ADDENDUM #3

**CITY OF EAST PROVIDENCE
DEPARTMENT OF PUBLIC WORKS - ENGINEERING DIVISION
REQUEST FOR PROPOSALS
EP24/25-026
STORMWATER QUALITY IMPROVEMENT RETROFITS**

Addendum No. 3 forms a part of the Contract Documents and modifies the original Bidding Documents dated September 22, 2025 as noted below.

Addendum #3 - Questions and Responses

ISSUED FOR BID

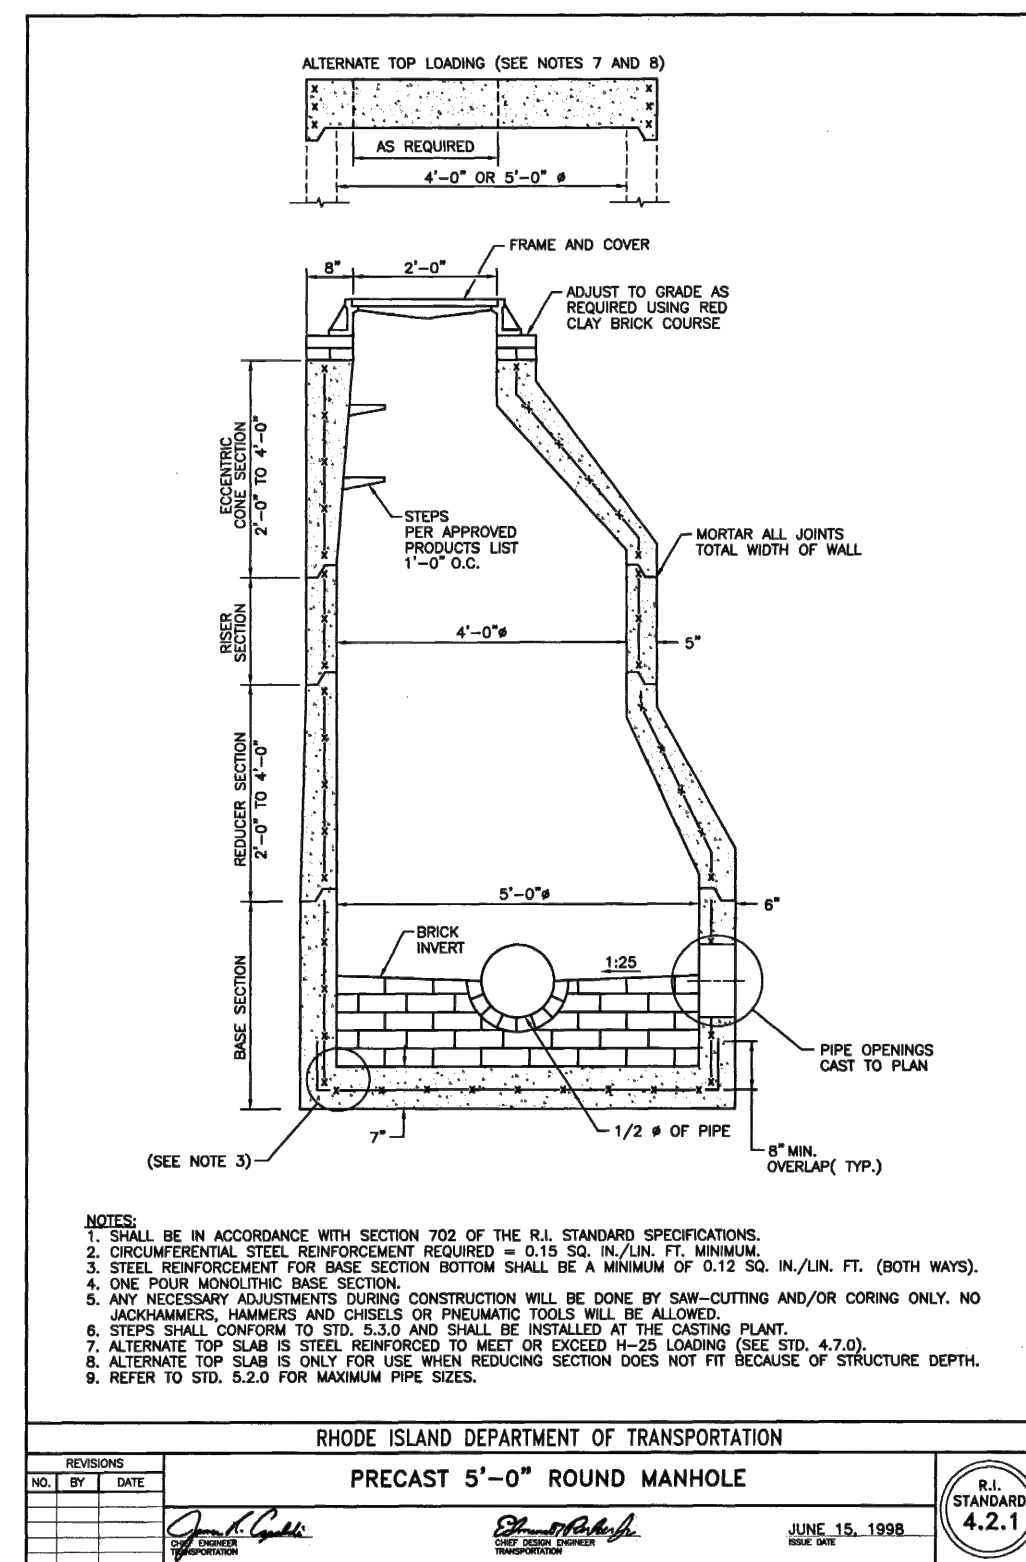
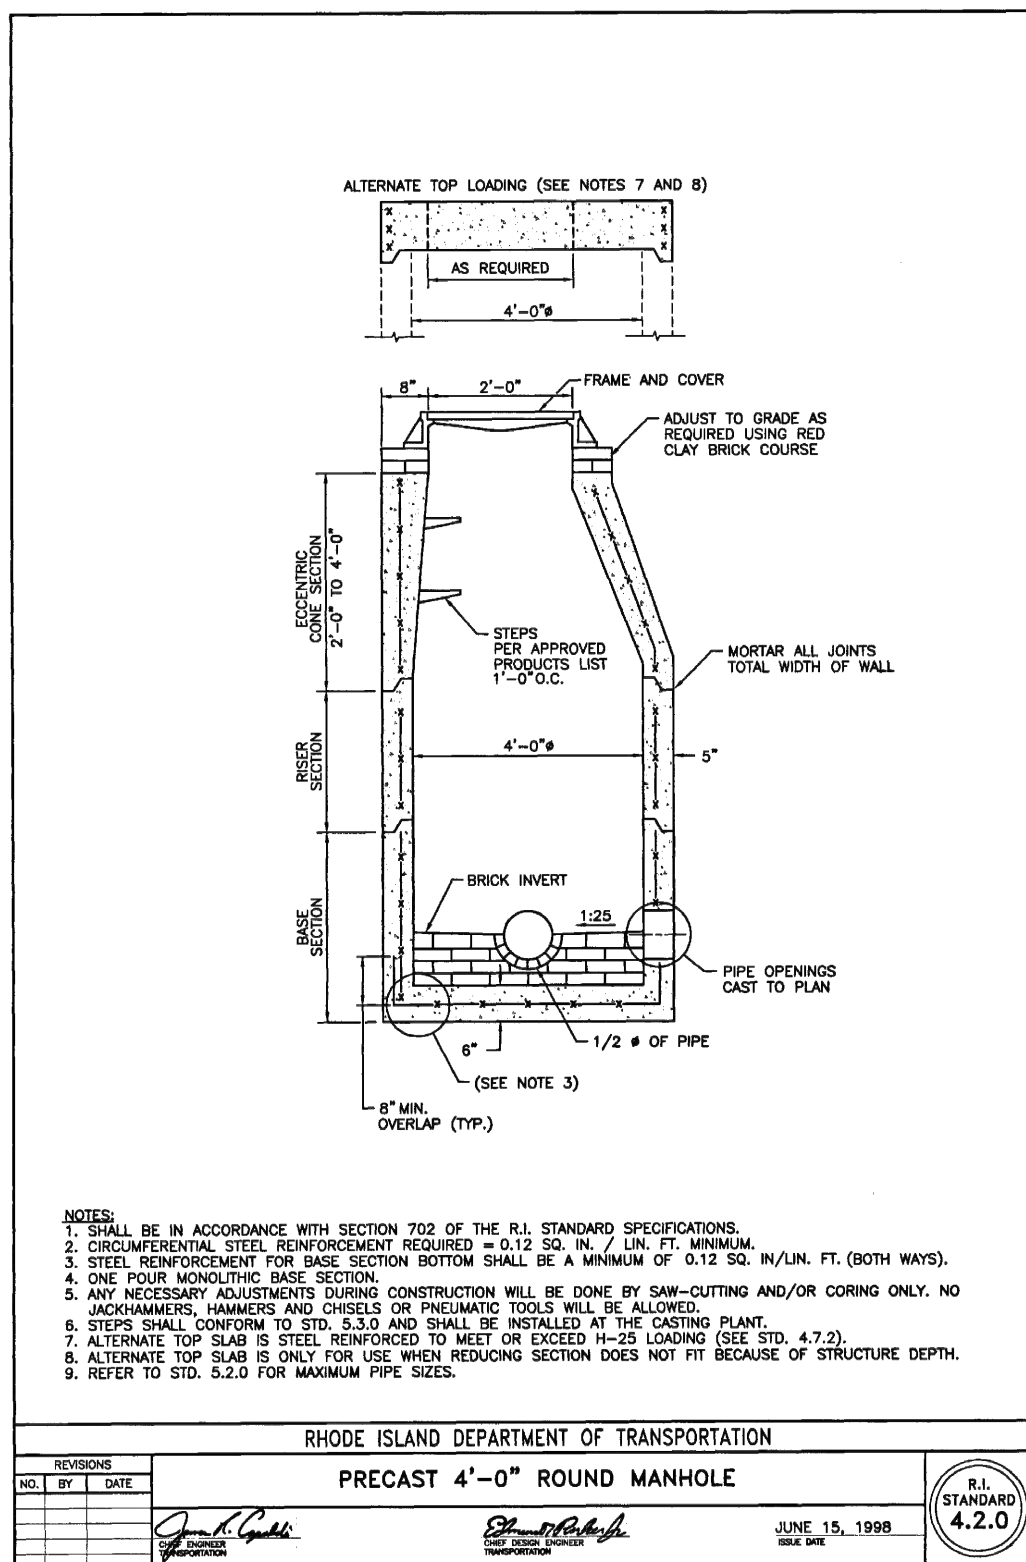
2. What pay item is "REMOVE AND REPLACE TIMBER GUARDRAIL" covered under referenced on drawing EC-1 also is there a detail for this?

5. Can you please confirm the match lines are in the correct locations for C-1/C-2 and EC-1 and EC-2?

The removal of the timber guardrail is covered under Item No. 2. It will not be replaced. The installation of new guardrails for both the sand filter (at the end of Locust Street) and the gravel wetland (at the end of Middle Street) is included under Item Nos. 4 and 6, respectively. Rhode Island Standard Detail No. 34.2.0 "Steel Beam Guardrail TL-3" is included on Drawing No. D-4. The guardrail should be installed in accordance with Section 901 of the Rhode Island Standard Specifications.

The match lines on Drawing Nos. C-1/C-2 and Drawing Nos. EC-1/EC-2 have been adjusted to the correct locations.

3
D-3

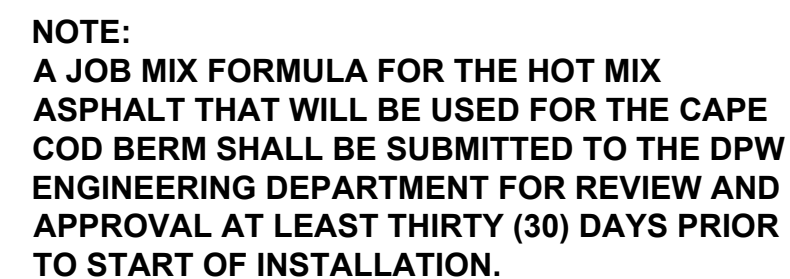
3. Plan page C-1 calls for a "TIDEFLEX GATE VALVE" on the end of a 29" x 45" elliptical pipe and references detail 6 on drawing D-2. Drawing D-2 had no reference to this. Drawing D-3 detail 3 references a "TIDELFEX SERIES TF-1 CHECK VALVE DETAIL" but shows a 30" RCP OD. Please advise

The detail has been deleted. The Tideflex gate valve as specified in the Bid documents is to be a TF-1 duck bill style gate valve or equivalent to be installed on the 29" x 45" elliptical reinforced concrete pipe.

The reference to the 30" TF-1 Tideflex check valve detail has been removed. The gate valve will be a TF-1 duck bill style gate valve or equivalent to be installed on the 29" x 45" elliptical pipe.
